**SUBJECT:** Service Update for Inventory and Customer Vehicles  
Power Steering Hose Leak  
Expires with Base Warranty

**MODELS:** 2015 Chevrolet Silverado 2500/3500 HD  
2015 GMC Sierra 2500/3500 HD  
Serviced Before September 9, 2014 (Pursuant to Recall Bulletin 14356)

Subject: 14608A – Service Update  
Power Steering Hose Leak  
Revised Parts Information

3975435

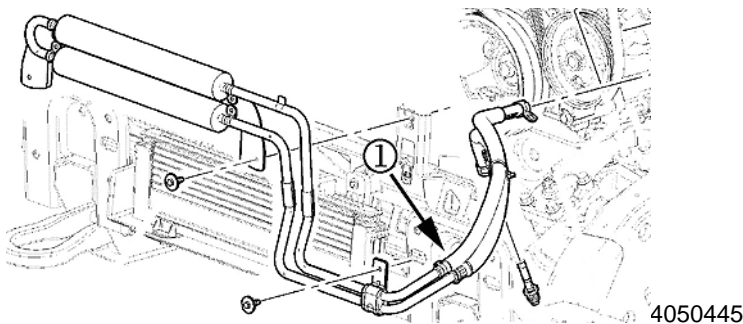
(A) Crimped ferrule with swedge marks. This is a secure connection on the pipe ferrule. (B) Uncrimped ferrule without swedge marks. This is NOT a secure connection on the pipe ferrule.

1. Open the hood and locate the section of the power steering cooler lines where the rubber hoses join the metal pipes (1).
2. Verify there is a metal collar (ferrule) on the both rubber hoses where they join the metal pipes.

3. Verify that both ferrules are crimped and display the swedge mark. Pull on the crimped end of the hose to determine if hose crimp is loose (not secure) on the pipe ferrule.

- If the power steering hose crimps are secure and show evidence of swedge marks AND the power steering hose clamps are engaged at both the power steering pump and gear locations, no further action is required. Refer to *Power Steering Fluid Leaks* in SI to diagnose any fluid leaks.

- If the power steering hose is missing a ferrule, the crimps are NOT secure or DO NOT show evidence of swedge marks, **replace the power steering fluid cooler**. Refer to *Power Steering Fluid Cooler Replacement (Heavy Duty)* in SI.
